ALERT SERVICE BULLETIN

NO. 206-09-119

MODEL AFFECTED: 206B

SUBJECT: VERTICAL FIN ASSEMBLY 206-020-113-231,
INSPECTION OF

Figure 1 (sheet 1 of 2) – Vertical fin assembly, inspection and repair of

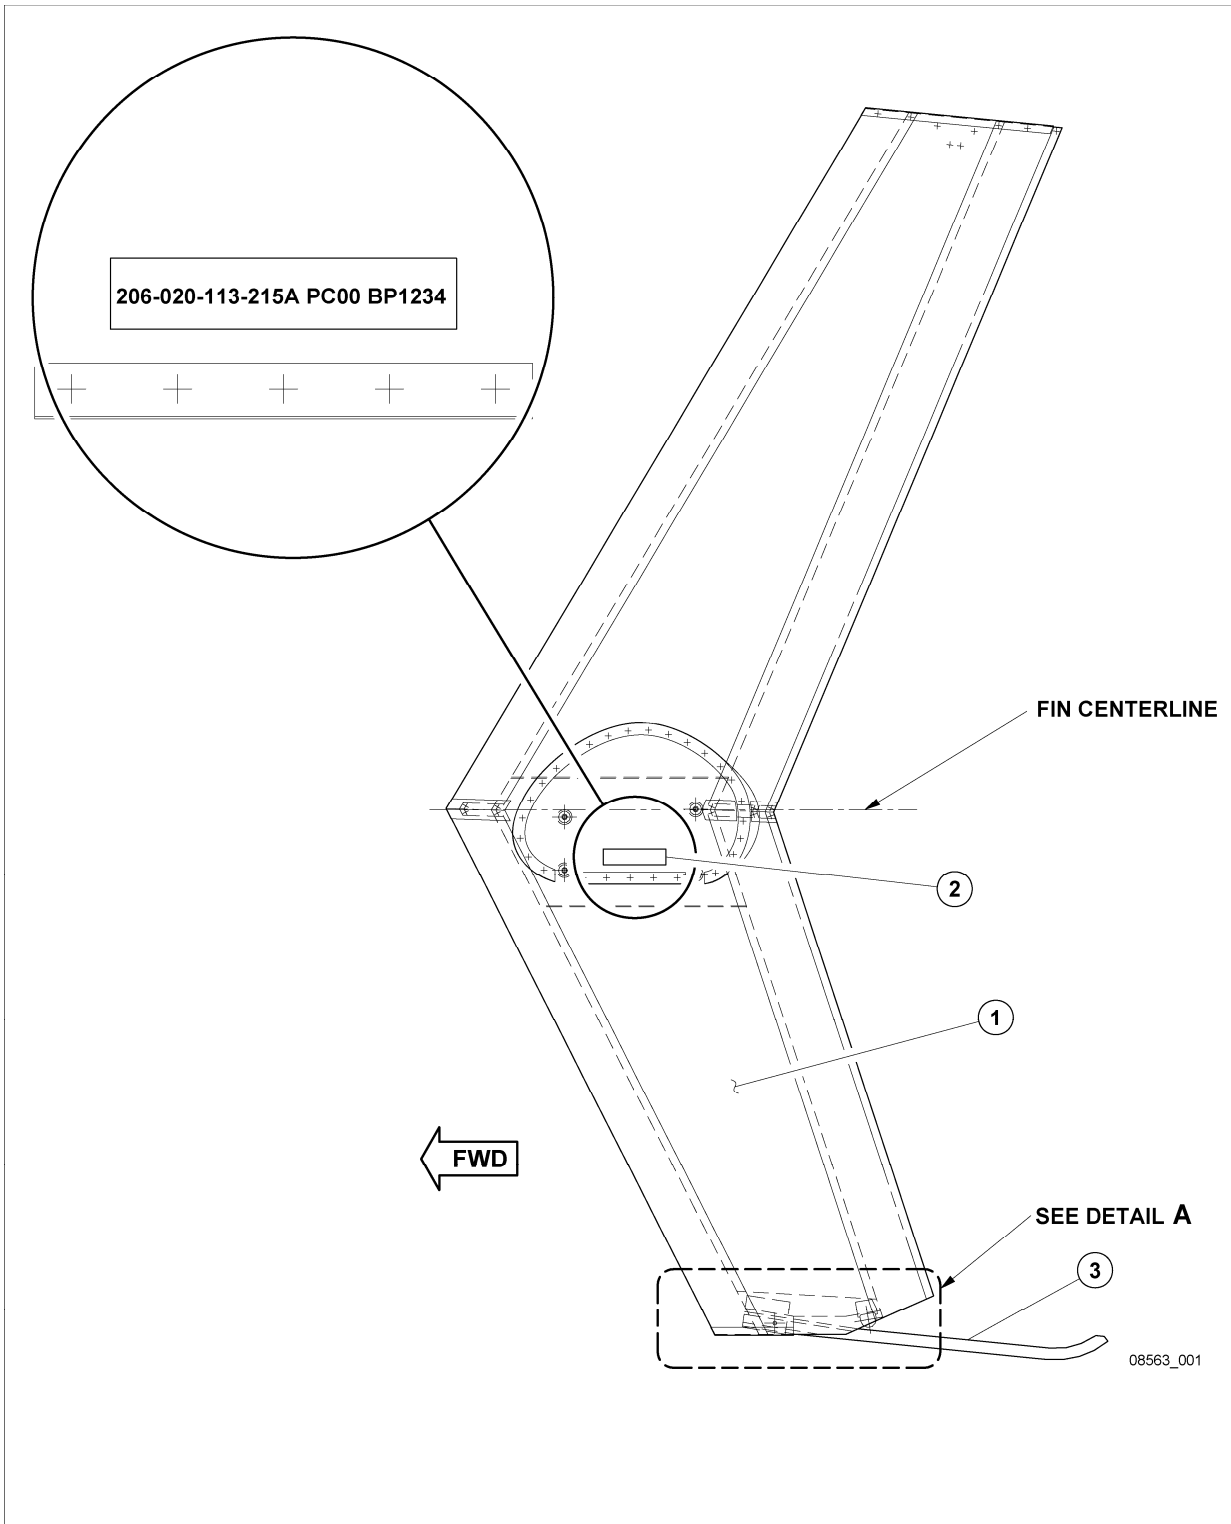
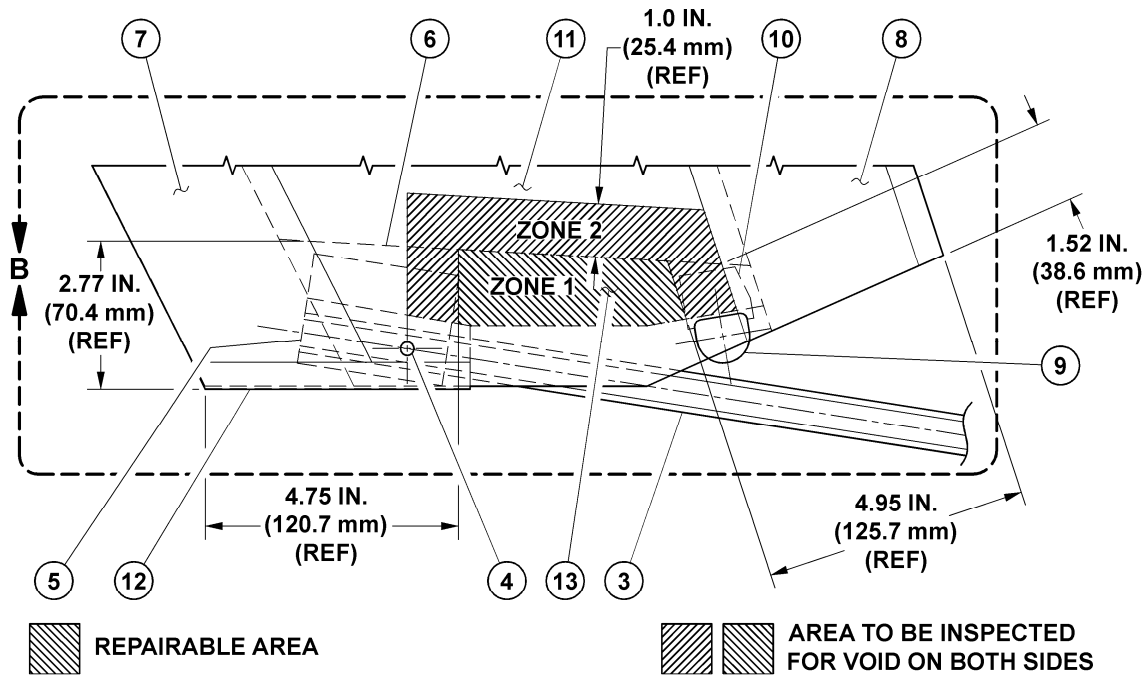
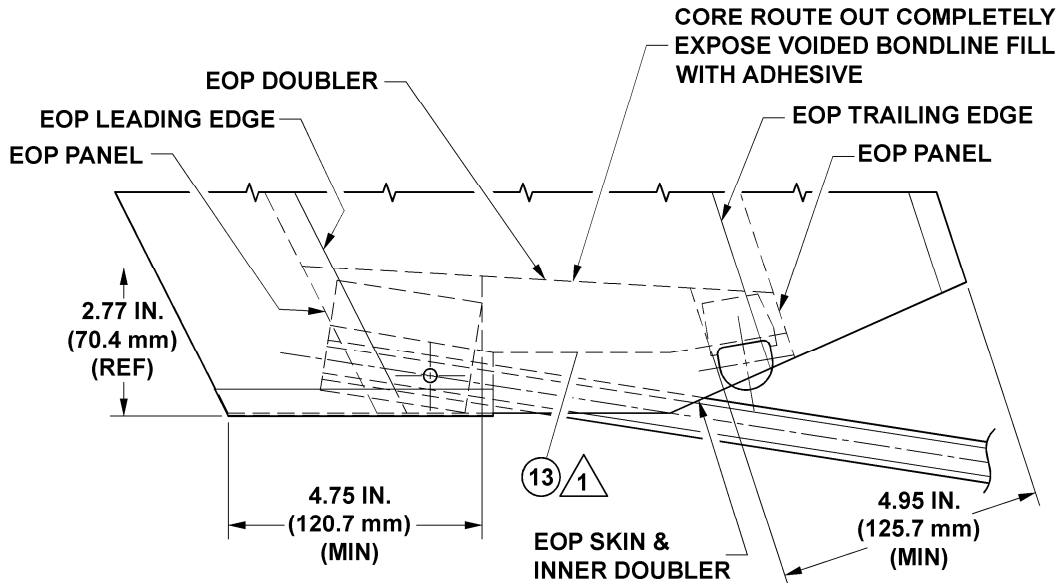
3. Refer to Figure 1. Determine if you have an affected vertical fin assembly (1) using the serial number of the core 206-020-113-215A as listed in Table 1. An identification tag (2) showing the P/N 206-020-113-215A followed by its serial number is bonded on the fin assy as shown in the Figure 1.
4. If the serial number of the core is not listed in Table 1, reinstall the tail rotor gearbox fairing in accordance with BHT-206A/B-MM and make an entry to indicate that this bulletin has been accomplished.
5. If you have an affected vertical fin assembly, accomplish Part II of this bulletin.

1. Refer to figure 1, detail A. Using the tap test method, inspect Zone 1 and Zone 2 on each side of the vertical fin assembly skin (11) in the lower area shown on the Figure 1 for voids between core (13) and inner doubler (6).
2. Record size and total area of the void, if any.
3. Verify the limit of void for each Zone. Limits are as follows for Zone 1 and Zone 2.
 - a. Zone 1 and Zone 2: If no void is found or if any single void does not exceed 0.25 square inch and the total voided area is less than 10% of the affected area, vertical fin assembly is serviceable and does not require repair or replacement. Accomplish Part IV of this bulletin.

- b. Zone 1: If any single void exceeds 0.25 square inch or if the total voided area exceeds 10% of the affected area. Accomplish Part III of this bulletin.
 - c. Zone 2: If any single void exceeds 0.25 square inch or if the total voided area exceeds 10% of the affected area. The vertical fin is not repairable and must be removed from service immediately. Order a new replacement fin and reinstall in accordance with BHT-206A/B-MM. Make an entry to indicate that this bulletin has been accomplished.
4. Notify your local CSR and Product Support Engineering that non-repairable vertical fin assembly has been removed from service and destroyed.

1. Refer to BHT-206A/B-MM. Remove tail skid assembly (3) from the vertical fin (1). Keep for reinstallation.
2. Remove the vertical fin assembly (1) from the helicopter, if installed.
3. Position vertical fin assembly (1) on a padded working table.
4. Refer to Figure 1, detail B. Remove layer of sealant covering the lower portion of the core (13).

5. Remove and route the entire honeycomb core (13) as shown in detail B with care. Exceeding the maximum area that is permitted will cause the vertical fin to be replaced.
6. Inspect the exposed area of core inside the vertical fin (1), and inner doublers (6) for corrosion, contamination, or any other damage. If such damage exists, contact Product Support Engineering for further assistance.

8. Clean surface of the inner doublers (6) with Acetone C-316 or equivalent.
9. Position and secure the vertical fin assembly (1) upside down.
10. Fill exposed area with adhesive C-317 and allow curing at room temperature for 24 hours.
11. Inspect the repair areas for voids and unbonded areas using the tap test method. Voids shall not exceed 10% of the total area that has been repaired . No one single void shall exceed 0.25 square inch. Repeat step 5 thru 10 if any voids are exceeding these limits.
12. Seal lower edge of the vertical fin with sealant C-392 and allow to dry.
13. Refinish vertical fin assembly as required.
14. Refer to BHT-206A/B-MM. Reinstall vertical fin assy (1) on helicopter.
15. Reinstall the tail skid assy (3).
16. Accomplish Part IV of this bulletin.

1 Cover entire edge of exposed core with sealant MIL-PRF-81733.
